20150128-0032.FERC PDF (Unofficial) 01/28/2015

IND136 Continued, page 2 of 4

Figure 1. From Zhang (2012). NAVD88 is basically the level of Mean Higher High Water. The scale in meters translates as 10 m ~ 33 feet. North, West, etc are model estimates for water heights at three sides of the JCEP ship-loading basin.

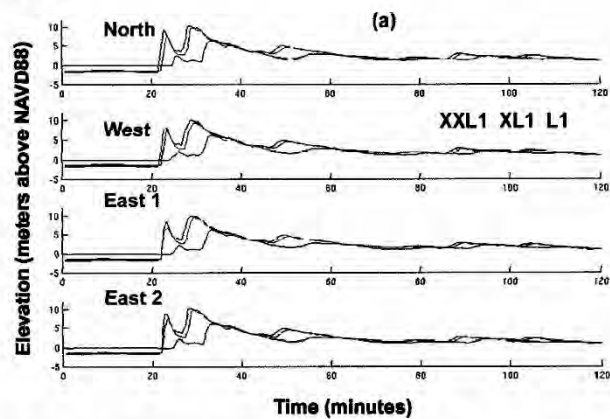
The Zhang model results are not explicitly shown in the EIS. They are shown in attached Figure 1. The projected run-up amounts to about 10 m or +30 feet, which, apart from a +60 ft wall around the LNG storage tanks, is the tsunami from which the design engineers hope to protect the terminal and power plant. While this is a solid analysis so far as it goes, it does not go nearly far enough. Problems:

- (1) The model's incoming wave rises from a high tidal stand, and then returns to it. Initial waves of real tsunami inside embayments like Coos Bay do arrive without much initial outflow (unlike on adjacent beaches), but they are followed by arrival of the tsunami wave trough, which can drop water level as far below the tidal stand as the initial wave was above it (Figure 2). Since the proposed LNG-carrier mooring basin will be only a few feet below carrier draft, a carrier will almost certainly be grounded, potentially damaging its hull, propellers and rudder.

- (3) Real tsunami sequences are not just one wave (Figure 1). That is admitted in the EIS, to the extent that likely intervals to second and third waves, characterized as decreasingly great, are given (pages 4-244 & 245), though not shown in the Zhang model. After both the 1964 Alaskan and 2011 Tohoku, Japan, subduction earthquakes, the series of waves actually continued from 10 to 20 hours, wave after wave, often with the greatest amplitudes many hours into the sequence.

Figure 4.13-15. MR Overpressure Scenario at Train 2

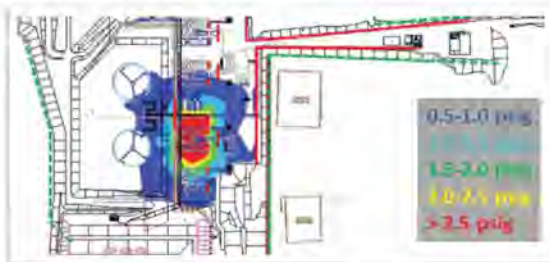
The mixed refrigerant spill overpressure calculations are also stated to indicate approximately 2.3 psig overpressure at the LNG storage tanks. This statement is then followed by "Jordan Cove stated that the LNG storage tanks would be designed to withstand an overpressure of 2.3 psig"... and that "We (presumably FERC) conclude that the siting of the proposed Project would not have a significant impact on public safety". As we stated in our comments filed January 14, in our opinion this statement assumes a precision and accuracy of the model predictions for which there is no supporting evidence.
